Access Compliance Report

Public Rights-of-Way

(Pedestrian Signals)

Intersection ID: N/A	Main Street:	Cross Street: N/A	Location: N/A
ADA ID: 66FCCCB924D4	Signal Type: One Push Button-Non APS	Overall Compliance: No	Severity Score: BTN 1: N/A BTN 2: N/A No BTN: N/A
Codes/Mitigation Info/Possible Solution		Field Measurements/Component Compliance

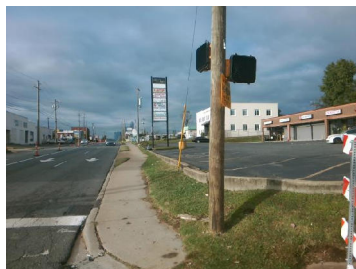
Possible Solutions: Provide PAR As Indicated. Remove and Replace Clear Space.

PROW/ADA: R404.3, R404.2, R406.2
